ADDENDUM #3 TO THE BID & SPECIFICATIONS

February 10, 2023

**BID SCHEDULE
CLEAR CREEK INTERCEPTOR - SANITARY SEWER PHASE A**

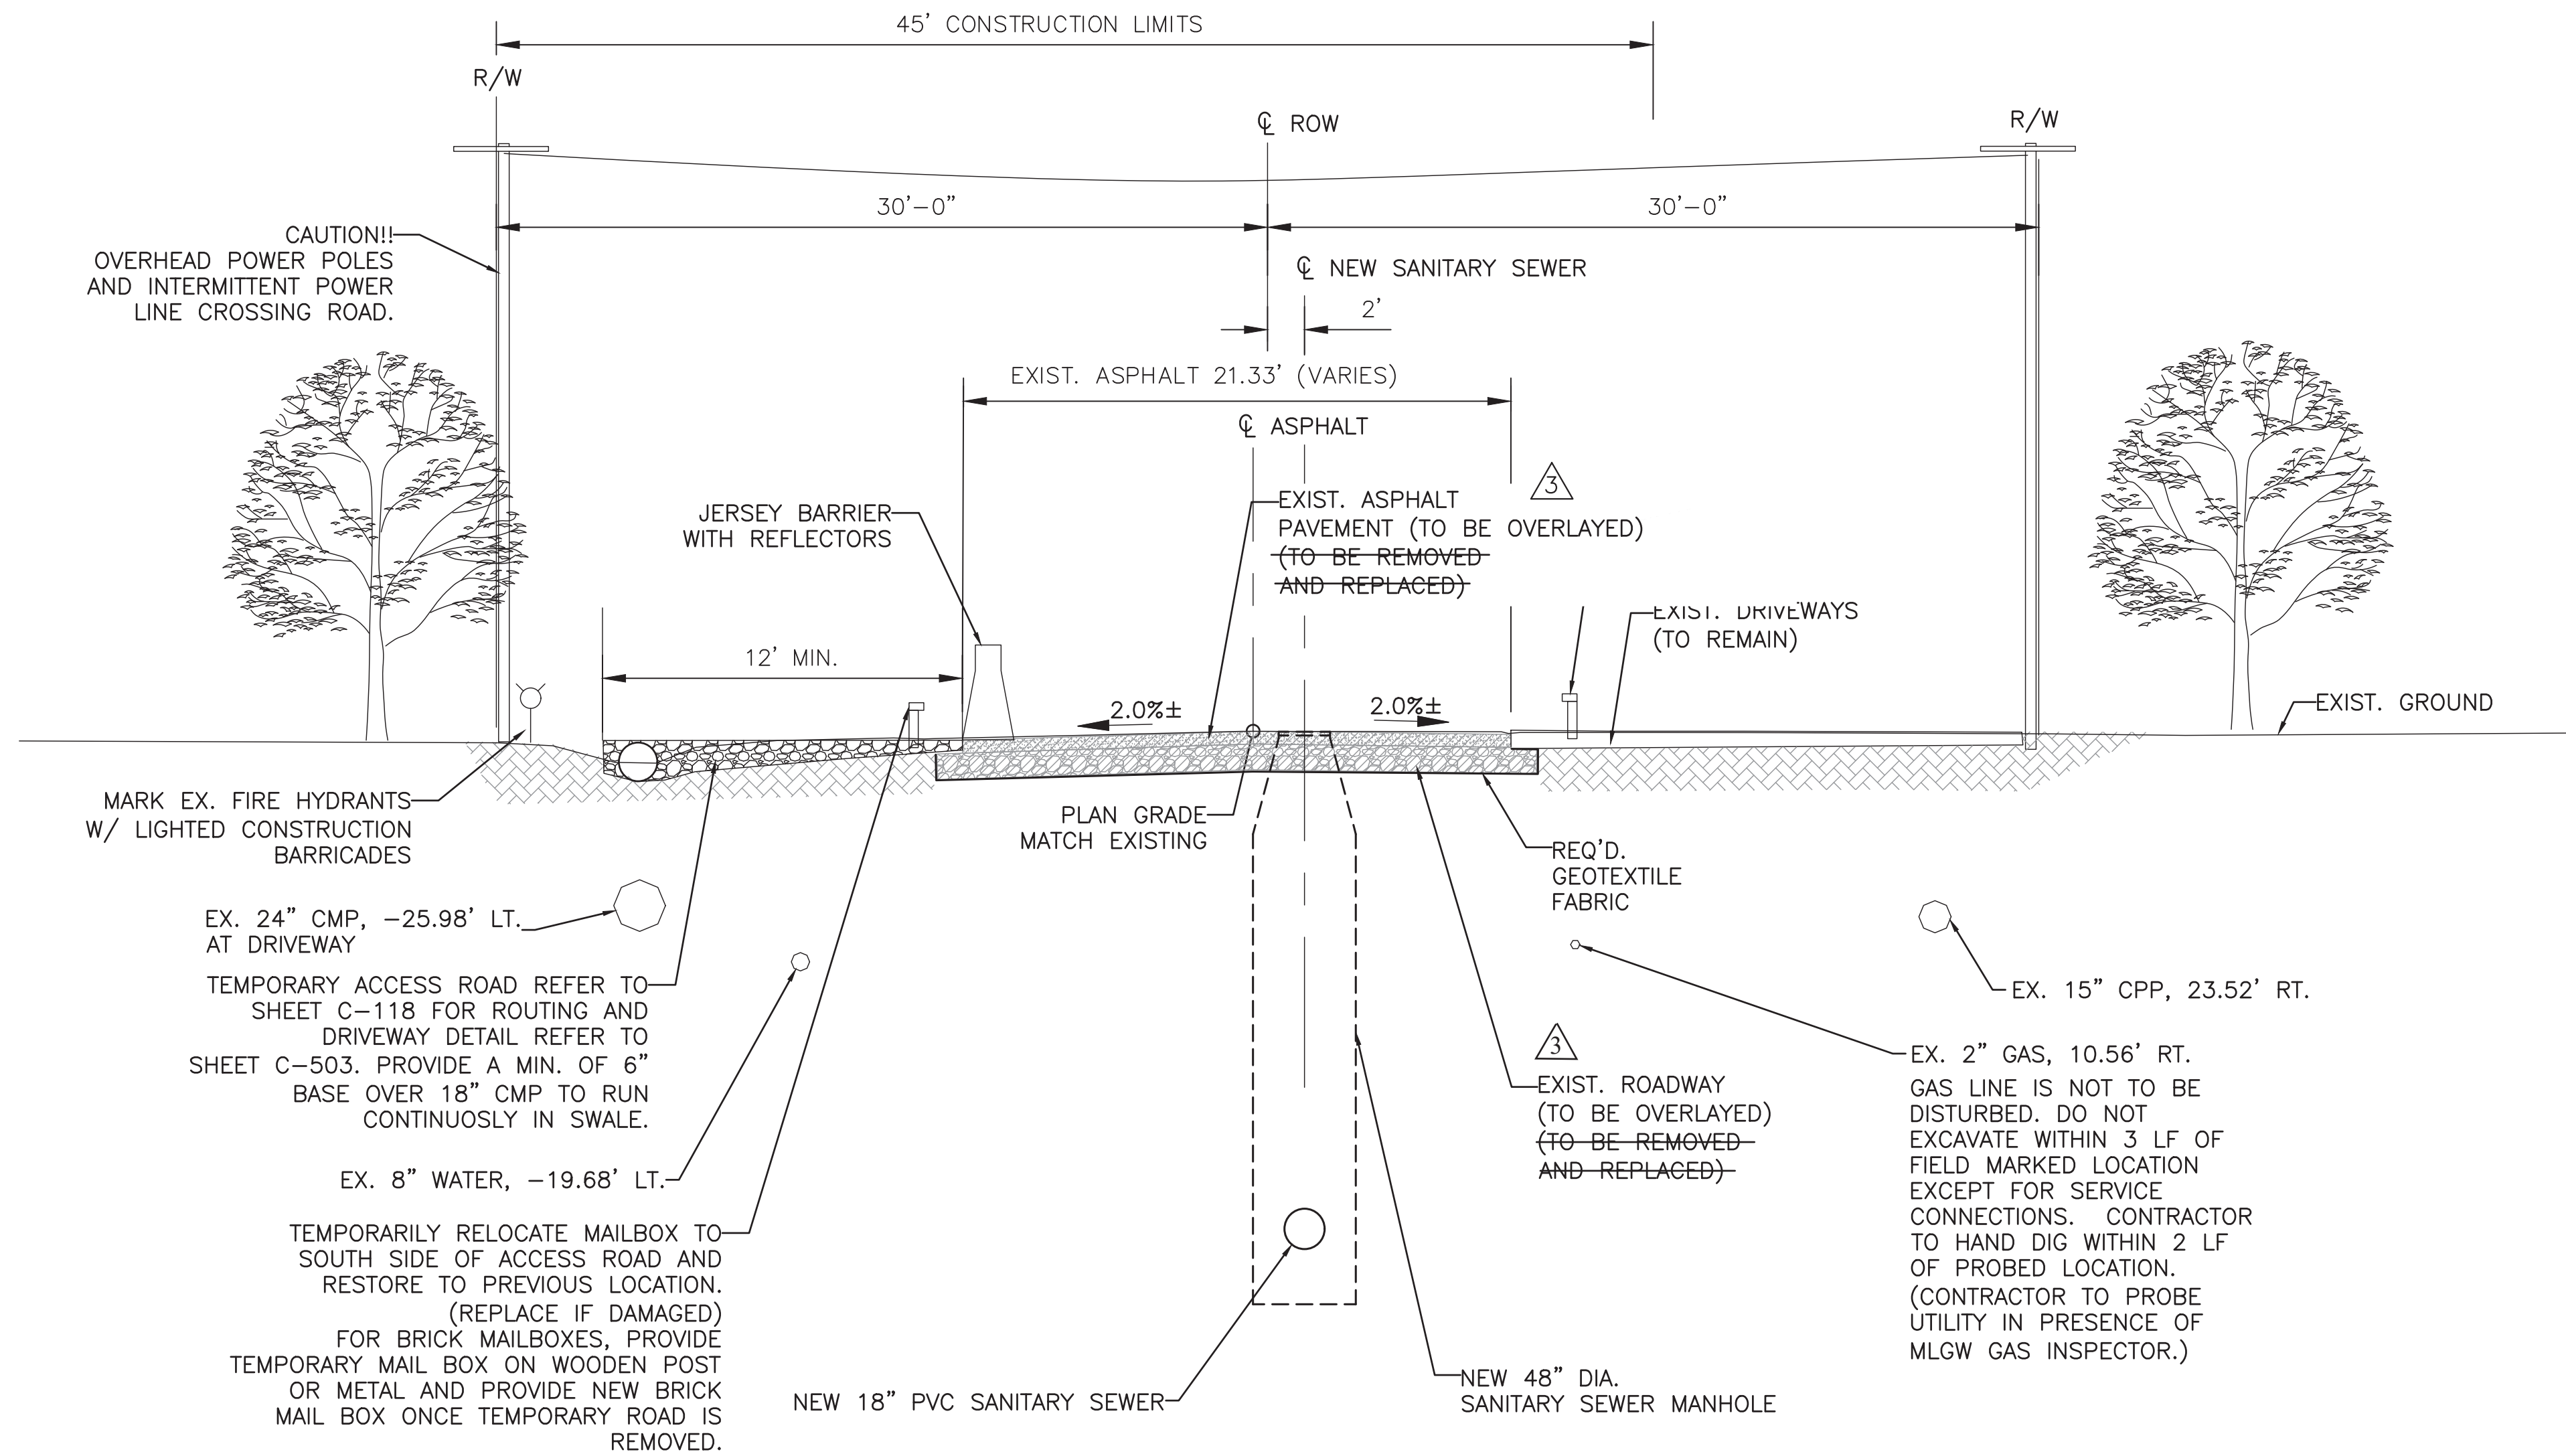
Replace Sheet G-004 with attached G-004. Changes include:

- Modifies note 26 to allow an extended Road Closure and provide additional requirements related to closure.

CONTRACTOR MAY CLOSE CHAMBERS CHAPEL ROAD TO THRU-TRAFFIC FOR A PERIOD OF TWO WEEKS. LOCAL TRAFFIC TO UTILIZE TEMPORARY GRAVEL ROAD. CONTRACTOR TO PROVIDE DRIVEWAY ACCESS TO RESIDENTS ON WEST SIDE OF ROAD USING PLATES OR FILLING TRENCHES WITH GRAVEL. IF CONSTRUCTION IS NOT COMPLETED WITHIN TWO WEEKS CONTRACTOR WILL BE REQUIRED TO OPEN ROAD TO THRU-TRAFFIC ON WEEKENDS UNTIL CONSTRUCTION IS COMPLETED. CONTRACTOR WILL BE REQUIRED TO SUBMIT A NEW TRAFFIC CONTROL PLAN TO ALLOW SAFE ACCESS FOR TWO-WAY TRAFFIC ON WEEKENDS.

CONTRACTOR MAY CLOSE CHAPEL HILL ROAD TO THRU TRAFFIC. LOCAL TRAFFIC, INCLUDING RESIDENTS EAST OF THE CUL-DE-SAC, TO UTILIZE TEMPORARY GRAVEL ROAD. CONTRACTOR TO PROVIDE DRIVEWAY ACCESS TO RESIDENTS ON NORTH SIDE OF THE ROAD AND EAST OF CUL-DE-SAC USING PLATES OR FILLING TRENCHES WITH GRAVEL.

DRAWING NO.
C-001

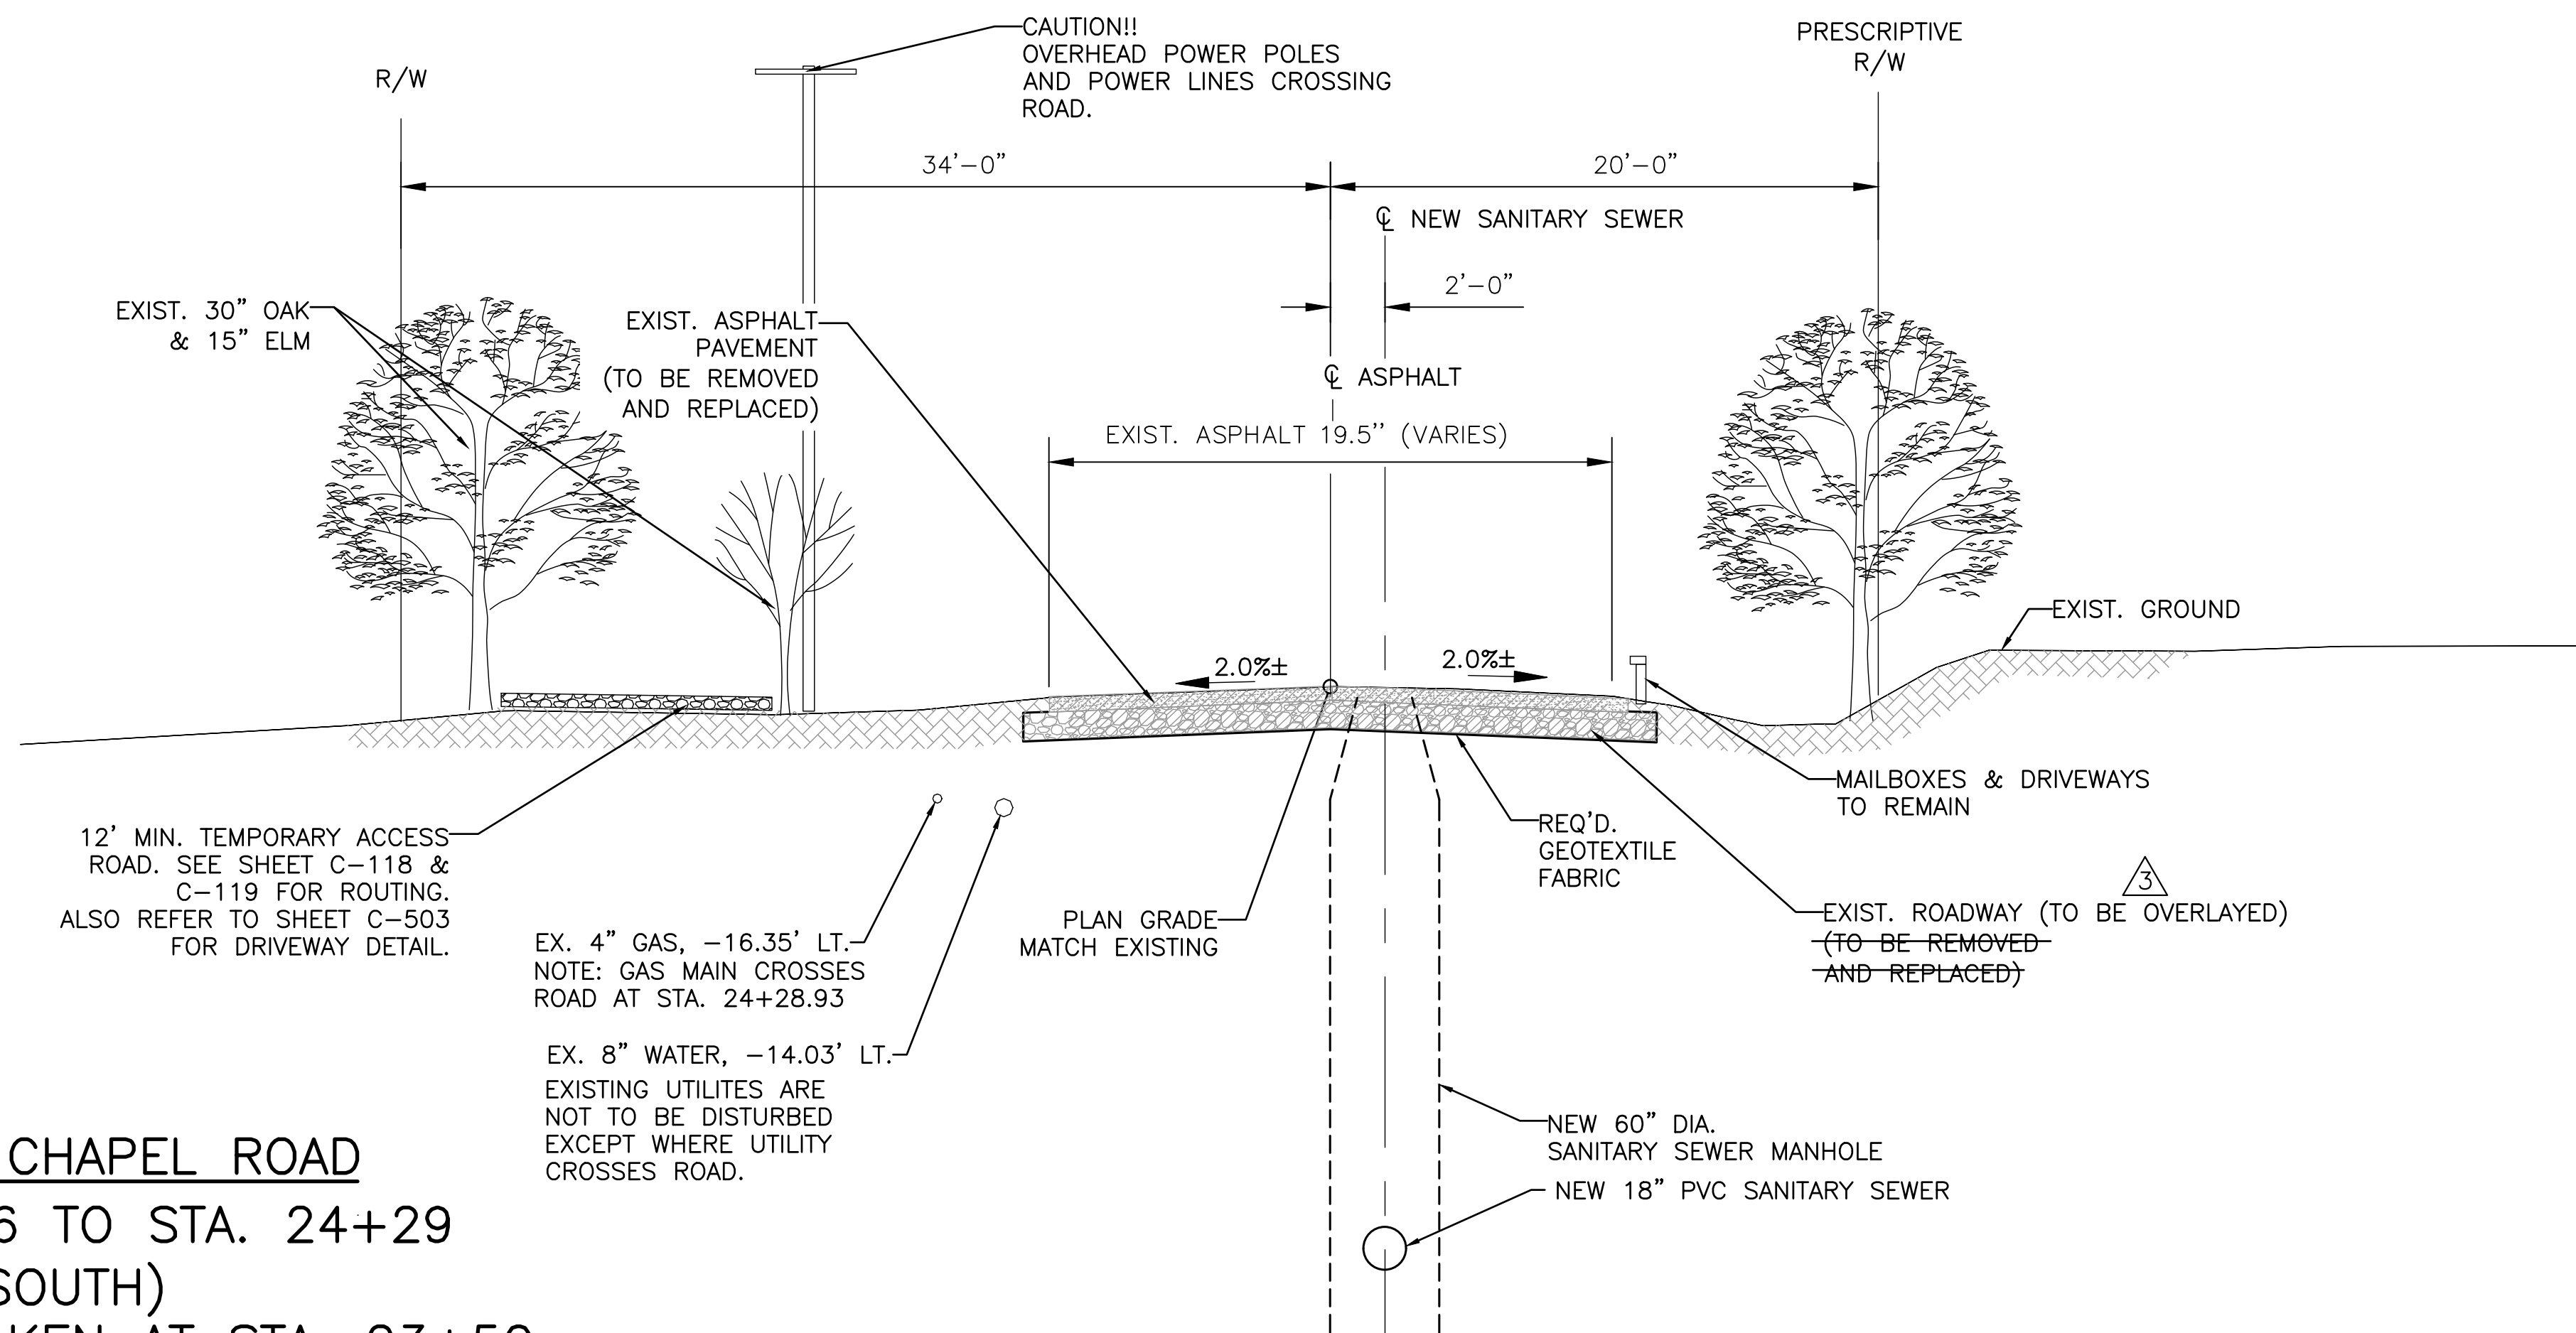
Replace Sheet C-001 with Attached C-001. Changes include:

- Modifies note “EXIST. ASPHALT PAVEMENT (TO BE REMOVED AND REPLACED)” to read ““EXIST. ASPHALT PAVEMENT (TO BE OVERLAYED)”
- Modifies note 4 to describe road overlay.

- ROAD IS INTENDED FOR FULL WIDTH OVERLAY. REFER TO TYPICAL PAVEMENT REPAIR DETAIL (C-502) AND EXISTING ROAD CROSS SECTIONS. PROVIDE 2%± SLOPE. PROVIDE 1½" WEARING COURSE (LAKELAND MIX 1) AND TDOT 403-01 BITUMINOUS MATERIAL FOR TACK COAT AT AN APPLICATION RATE OF 0.1 GAL/SY.

DRAWING NO.
C-002

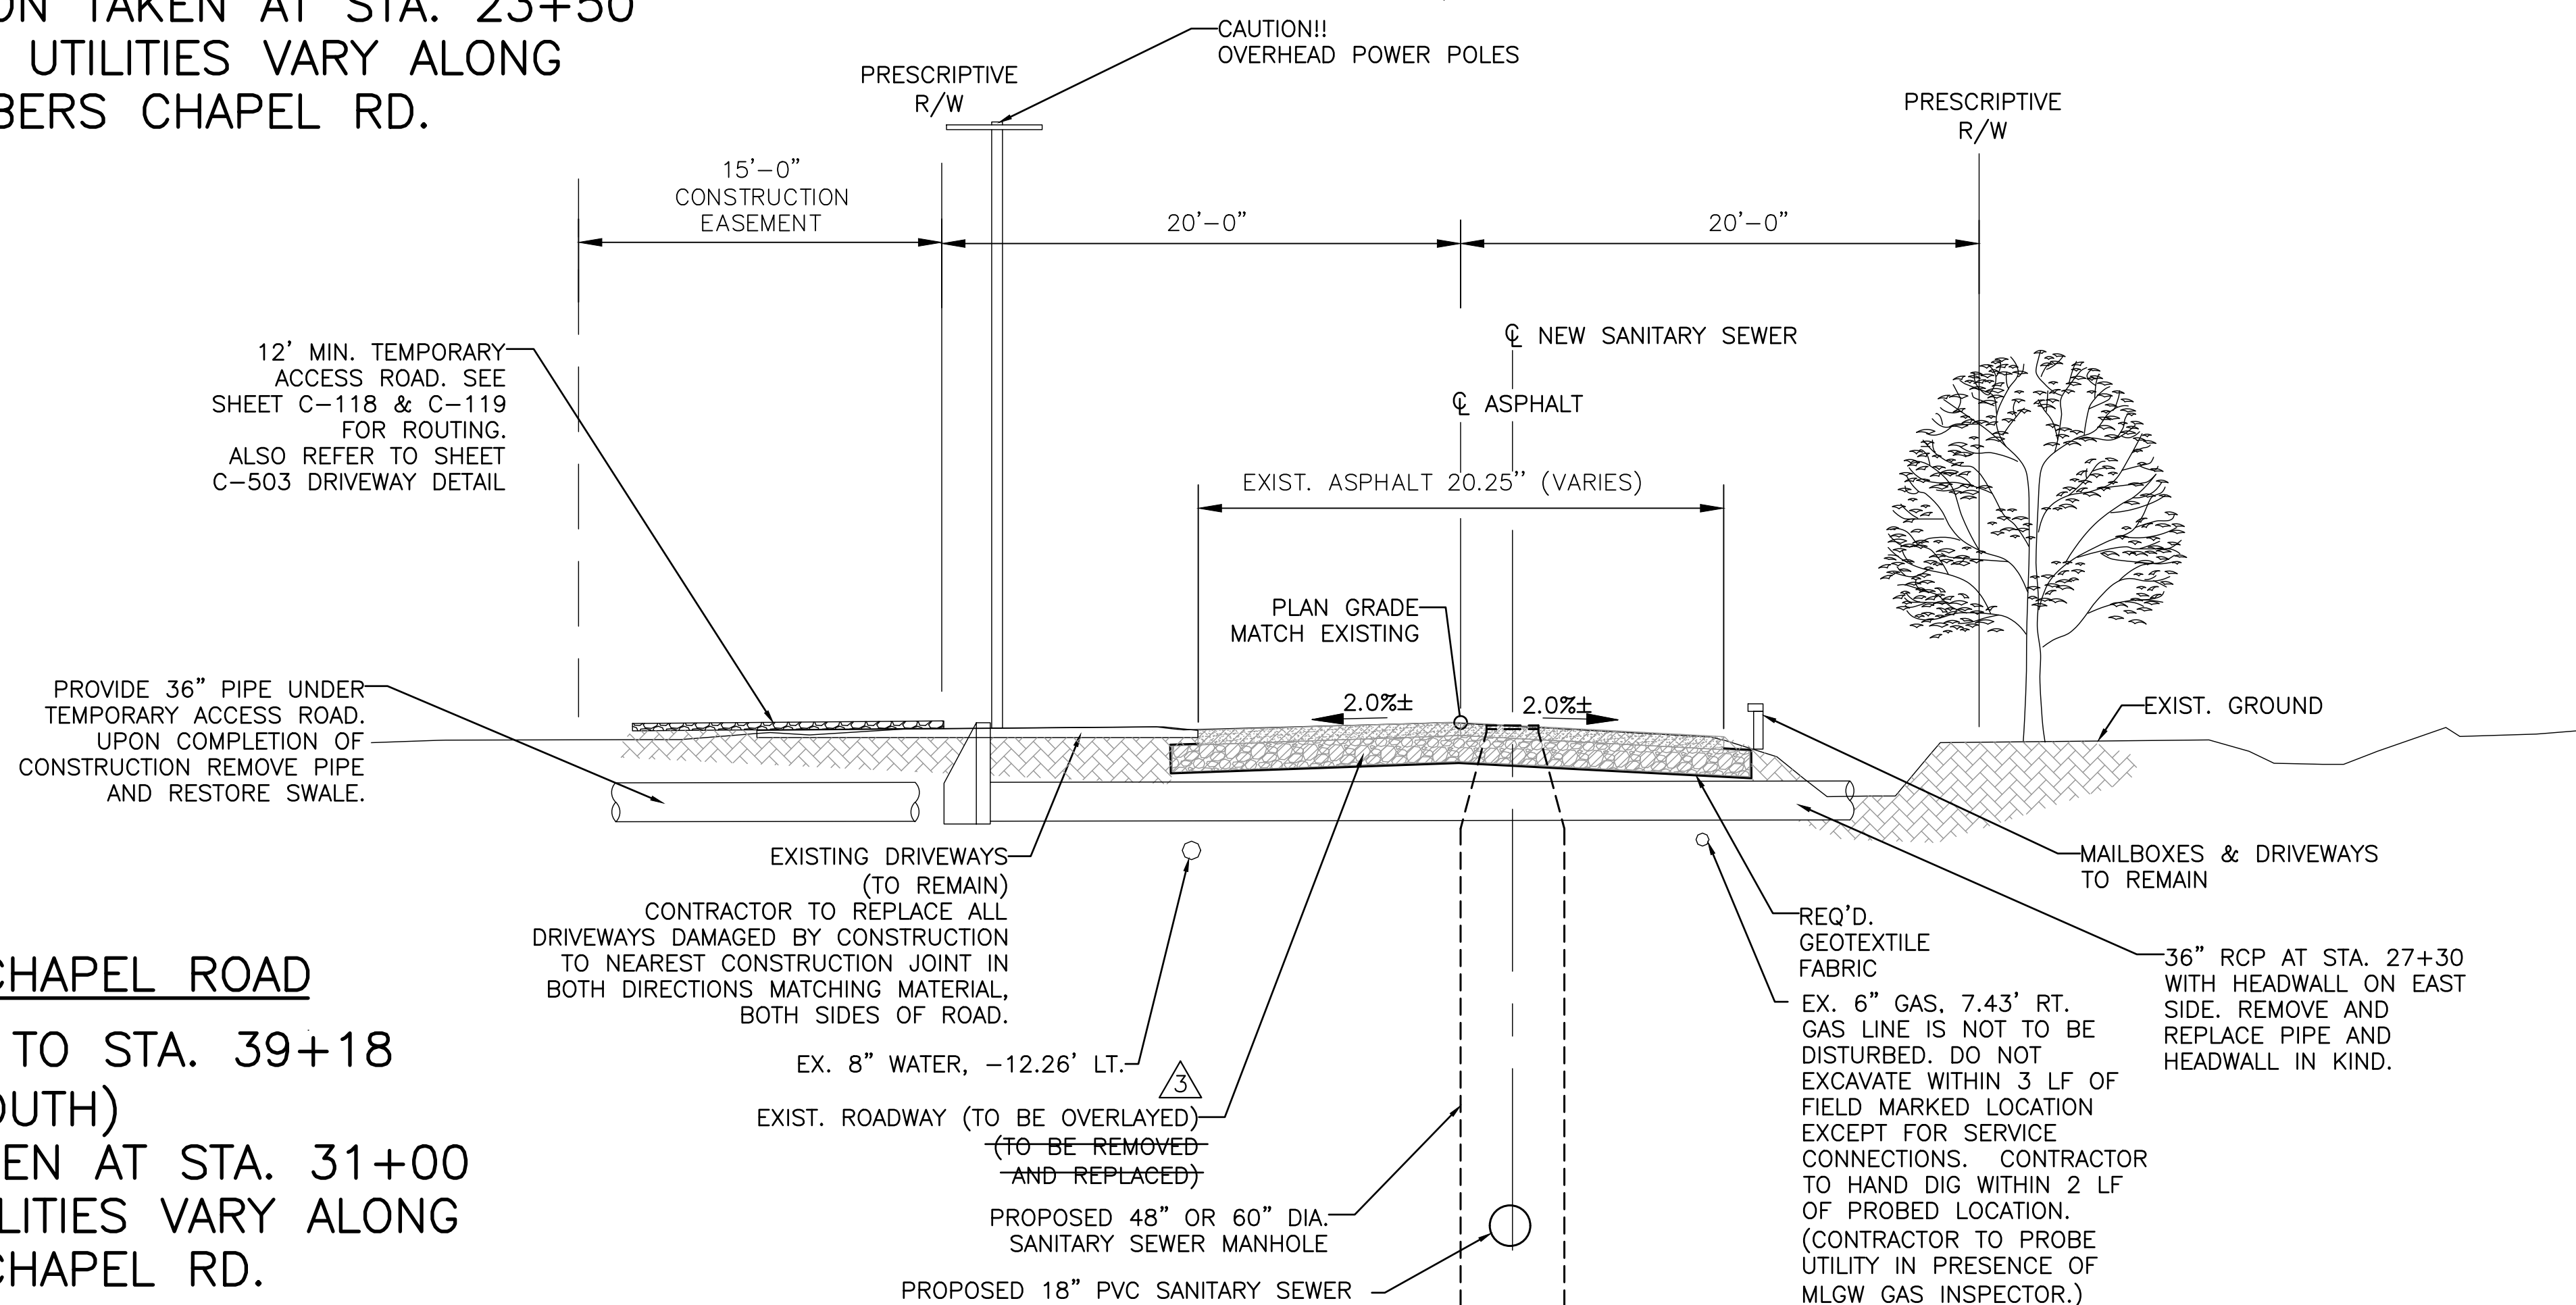
Replace Sheet C-002 with Attached C-002. Changes include:

- Modifies note “EXIST. ASPHALT PAVEMENT (TO BE REMOVED AND REPLACED)” to read ““EXIST. ASPHALT PAVEMENT (TO BE OVERLAYED)”
- Modifies note 4 to describe road overlay.
- Removes Note 6. Jersey Barriers are not required on Chambers Chapel Road.

- ROAD IS INTENDED FOR FULL WIDTH OVERLAY. REFER TO TYPICAL PAVEMENT REPAIR DETAIL (C-502) AND EXISTING ROAD CROSS SECTIONS. PROVIDE 2%± SLOPE. PROVIDE 1½" WEARING COURSE (LAKE LAND MIX 1) AND TDOT 403-01 BITUMINOUS MATERIAL FOR TACK COAT AT AN APPLICATION RATE OF 0.1 GAL/SY.
